Re: Development Application X/900/2011 for RFS Brigade Station 117-123 Shipley Road, Blackheath

The attached plans incorporate the following amendments:

Amended Drawings

Site Plan

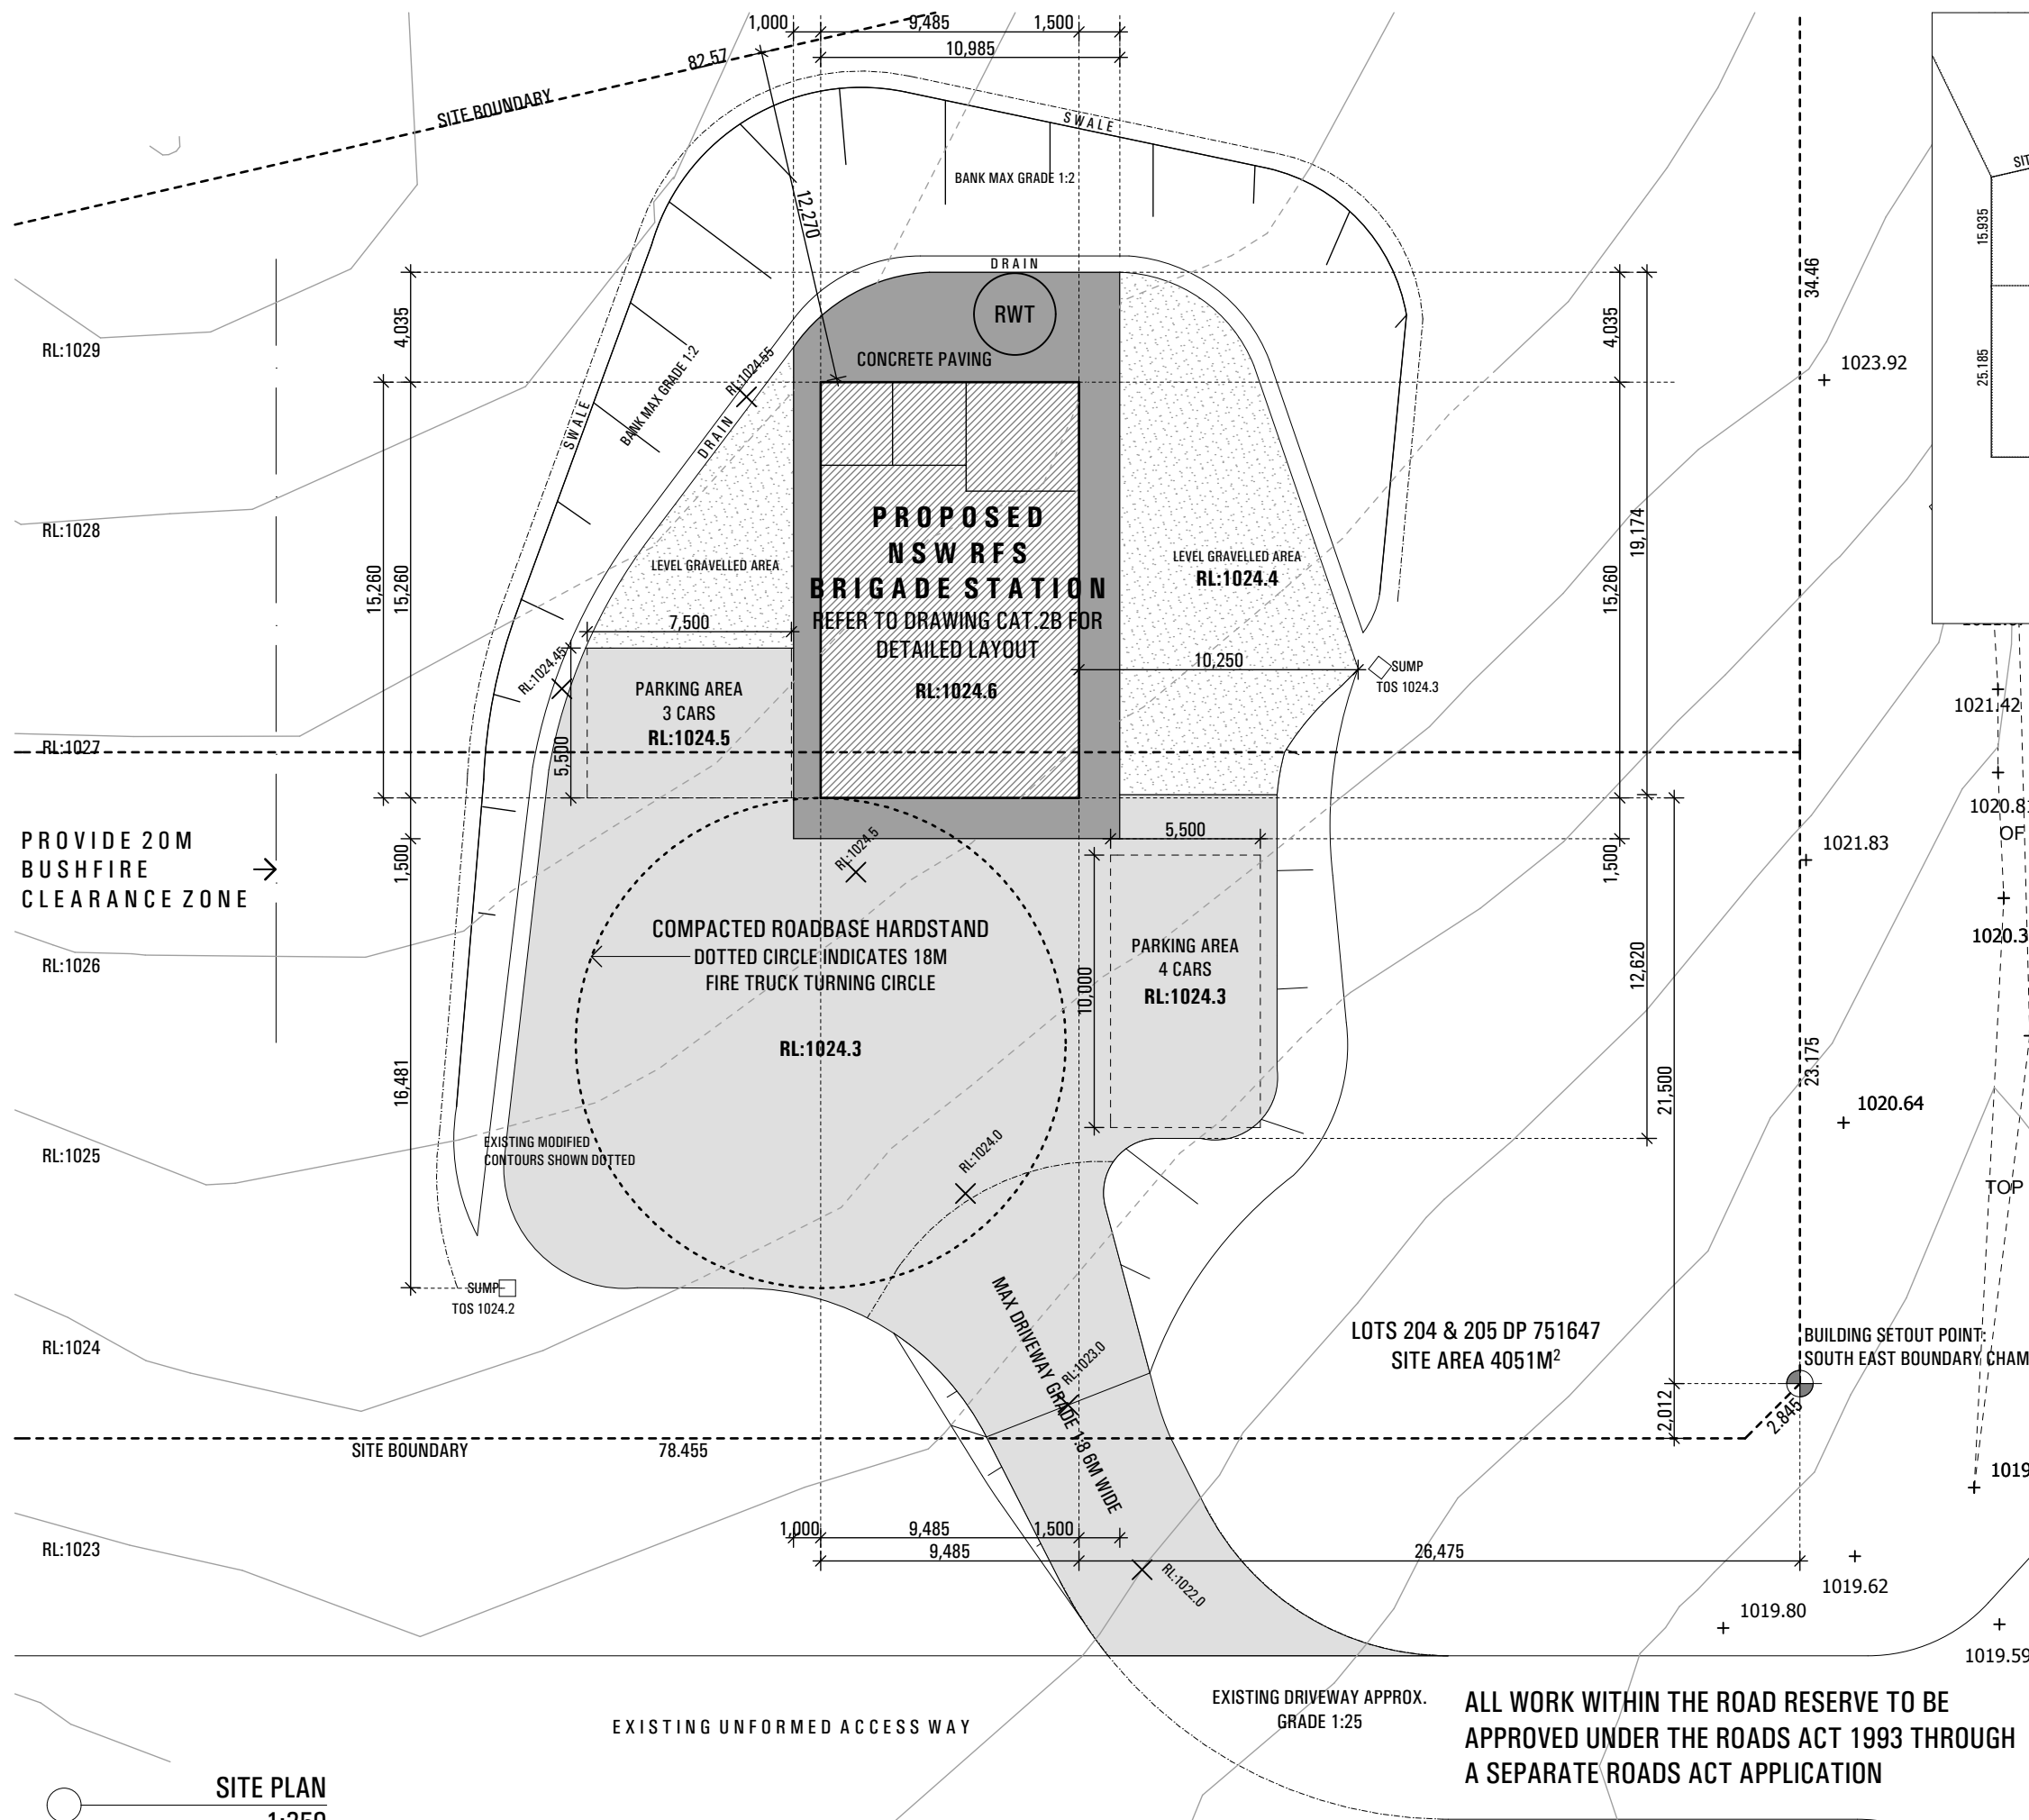
- A reduction in the size of the facility from a Category 2 Brigade Station to a Category 2A Station. Drawings of the Category 2A station are attached. The annexe containing the multi-function area, office and kitchenette has been deleted and one toilet removed. The kitchenette has been relocated to within the main part of the building.
- A consequential change to the site plan to show the smaller building and a reduced area of excavation. The site plan has also been amended to increase the size of the parking area as recommended by Council officers and to include a note regarding approvals under the Roads Act 1938 for works within the road reserve also as suggested by Council officers.

The building remains in the same location although smaller in size. Access and parking arrangements remain essentially the same. It is anticipated that the smaller facility will generate less waste water to be managed on site and would generate less traffic movement.
